Access Compliance Report

Public Rights-of-Way

(Curb Ramps)

Intersection ID: 28003	Main Street: COMMUNITY_HOUSE_RD	Cross Street: WILLOW_ROCK_DR	Location: SE
ADA ID: 385A4F96387B	Ramp Type: BlendTrans2	Initial Pass/Fail: Fail	Overall Compliance: No
Severity Score: 1.25			
Codes/Mitigation Info/Possible Solution		Field Measurements/Component Compliance

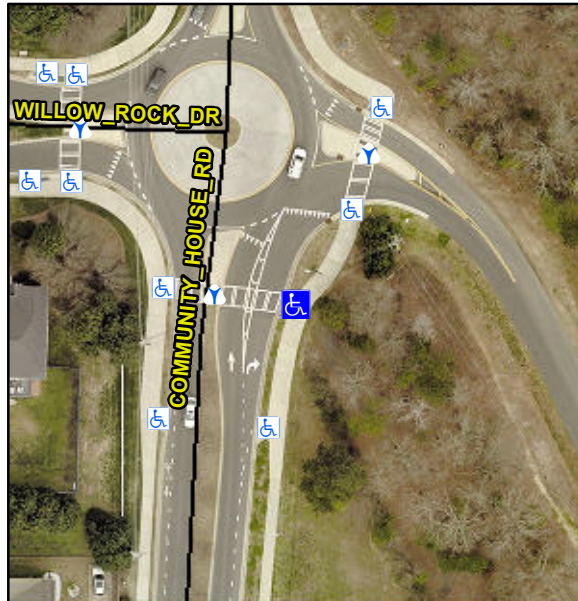
Not Found, R304.5.3

Compliance	Description	Data	Compliance	Description	Data
N/A	Ramp Length (in)	170.0	Yes	BlendTrans Slope (%)	2.0
Yes	Ramp Width (in)	119.0	No	BlendTrans XSlope (%)	3.3
N/A	Flare Type LT	N/A	N/A	Flare Type RT	N/A
N/A	Flare Slope LT (%)	N/A	N/A	Flare Slope RT (%)	N/A
N/A	Flare Traversable LT?	N/A	N/A	Flare Traversable RT?	N/A
N/A	Landing Length (in)	N/A	N/A	DWS Provided?	N/A
N/A	Landing Width (in)	N/A	N/A	DWS Contrast?	N/A
N/A	Landing Slope (%)	N/A	N/A	DWS Length (in)	N/A
N/A	Landing X Slope (%)	N/A	N/A	DWS Full Width?	N/A
N/A	Landing Curb? (Y/N)	N/A	N/A	DWS Offset (in)	N/A
N/A	Shared Landing?	N/A			
N/A	Gutter Ponding?	N/A	N/A	Gutter Slope (%)	N/A
N/A	Gutter Lip Ht (in)	N/A	N/A	Gutter X Slope (%)	N/A
N/A	Painted X Walk1?	Yes	N/A	Painted X Walk2?	N/A
	X Walk 1 Direction	To W		X Walk 2 Direction	N/A
	X Walk 1 Width (in)	129.0		X Walk 2 Width (in)	N/A
	X Walk 1 Slope (%)	5.3		X Walk 2 Slope (%)	N/A
	X Walk 1 X Slope (%)	1.8		X Walk 2 X Slope (%)	N/A

N/A	Ramp inside XWalk1?	Yes	N/A	Ramp inside XWalk2?	N/A
	Road Slope (%)	1.8		Clear Space?	N/A
	Road X Slope (%)	5.3	N/A	Clear Space to XWalk (in)	N/A
N/A	Any Obstructions?	N/A	N/A	Storm Grate/Utility Hazard?	N/A
	Obstruction Type			Storm Grate/Utility Type	
		N/A			N/A
			Yes	Surface Condition? (G/P)	Good
			No	Curb Slope (%)	5.8

Remove & Replace Curb Ramp With Two New Directional Ramps or Equivalent.
